# Service Bulletin

JULY 1958 NO. 339

## Studebaker and Packard

Fig. 1

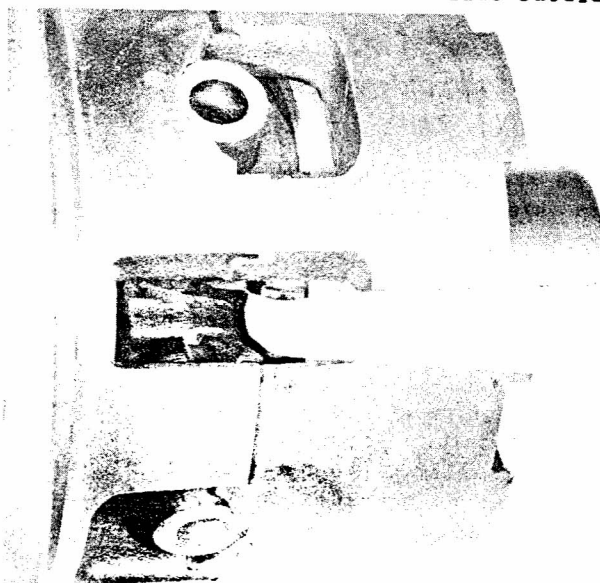
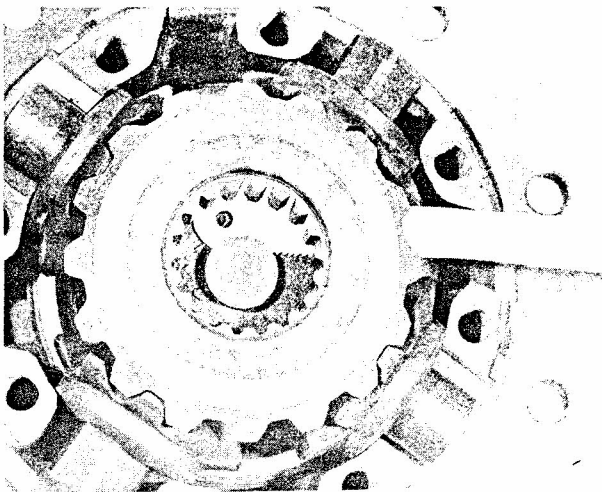
When removing an axle shaft, one end of the shaft thrust pin may be pulled out of position and the roll pin which retains the two parts of the thrust pin may drop out. This is usually not discovered until you attempt to reinstall the shaft; because the thrust pin is out of position, it will not permit the full installation of the shaft. This, of course, makes it necessary to tear-down the axle and replace the thrust pin and retaining roll pin.

1. Drain the rear axle differential case.
2. Remove the differential case cover.
3. Using a modified hacksaw blade as shown in Figs. 1, 2 and 3, insert the hacksaw blade between the pinion mate shaft and the differential side gear. The hacksaw blade should be

positioned so that it bears against the thrust pin with the saw teeth forward.

4. Pressure should be maintained against the hacksaw blade and thrust pin while the rear axle shaft is removed. The hacksaw blade should be placed between the pinion mate shaft and right hand differential side gear while removing the right side axle shaft and between the pinion mate shaft and left hand differential side gear while removing the left side axle shaft.

Fig. 4

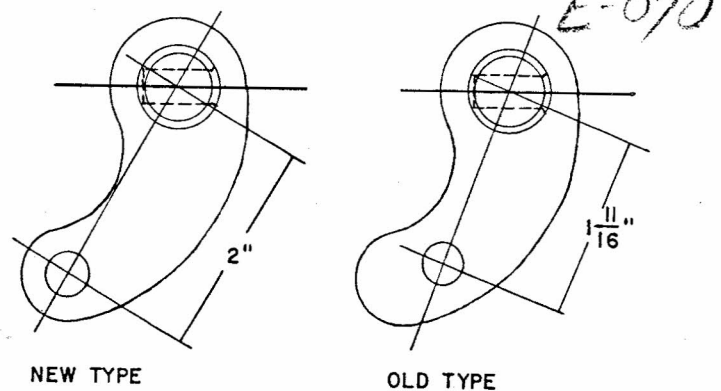
Under certain circumstances it is possible some gear clashing may occur even though the clutch pedal free travel is properly adjusted. Where this condition occurs it is recommended that Clutch Operating Shaft and Lever Assembly, Part No. 1546329, be installed.

This shaft and lever assembly has a lever radius of 2" instead of 1 11/16" radius originally installed and provides a greater release area for the clutch driven plate (See Fig. 4)

Effective with Serial No. G-1428648 the clutch operating shaft and lever assembly with the 2" lever radius entered production.
